UNITED STATES PATENT AND TRADEMARK OFFICE

APPLICATION NO.	FILING DATE	FIRST NAMED INVENTOR	ATTORNEY DOCKET NO.	CONFIRMATION NO.
10/010,939	11/07/2001	Harold G. Craighead	1153.009US1	5674

Office Action Summary	Application No. 10/010,939	Applicant(s) CRAIGHEAD ET AL.	
	Examiner Brian J. Sines	Art Unit 1743

DETAILED ACTION

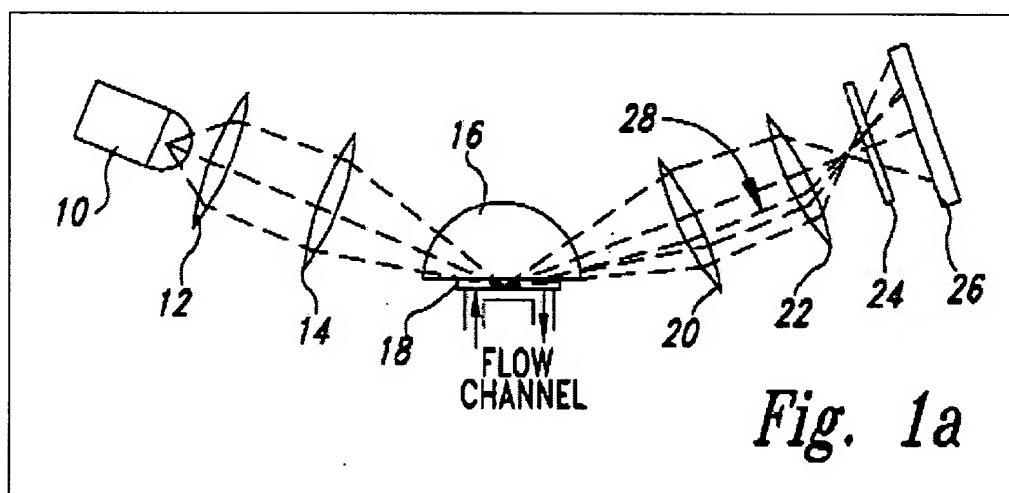
Regarding claims 1 – 5, 7 – 11, 13 – 17, 20 – 25, 42, 43 & 47 – 50, Malmqvist teaches a detection apparatus comprising: a duct, cavity, chamber means or flow channel comprising sidewalls; a glass support (30) coated with a thin gold film (32); a light source (LED 10); and a

light receiver or optical sensor (photodetector 26) (see figure 1a). Malmqvist teaches that the apparatus comprises glass (see col. 5, lines 16 – 30). Malmqvist teaches the incorporation of an immobilized binding partner, such as an antibody (38), for detecting target analytes (see col. 5, lines 16 – 30). Malmqvist indicates that the apparatus utilizes a surface refractive index measurement during operation (see col. 4, lines 21 – 30). The apparatus also comprises computer control and data-processing means (see col. 5, lines 7 – 12).

Regarding claim 18, the apparatus also comprises a prism (16) (see figure 1a).

Regarding claims 19 & 45, Malmqvist indicates that the apparatus can comprise a plurality of flow channels, each comprising a plurality of prisms (see figure 1b).

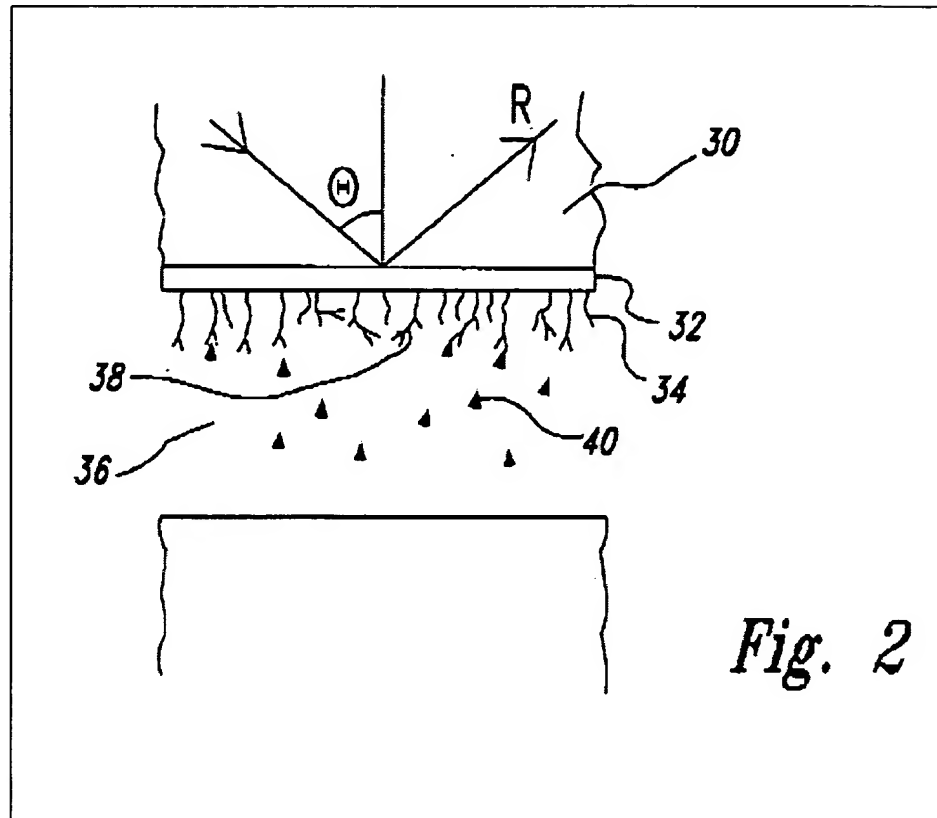
Regarding claims 6 & 46, Malmqvist teaches that the apparatus comprises a thin gold film (32) having a thickness of about 47 nm within the flow channel (36) (see col. 5, lines 16 – 30; figure 2). Thus, as shown in figure 2, it is inherently anticipated that the gap or channel width would be in the range of between 50 and 1,000 nm.
